Product Change Notification

Product Group: SFERNICE /Oct 20, 2006/PCN-SF / FL 046- 2005 Rev 0

TRIMMERS: TSM4 / TS63 / T63

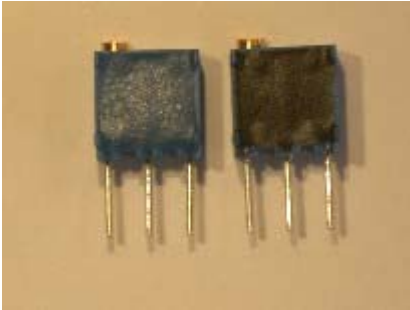
DESCRIPTION OF CHANGE: Sealing becomes BLACK (was blue) due to raw material obsolescence.
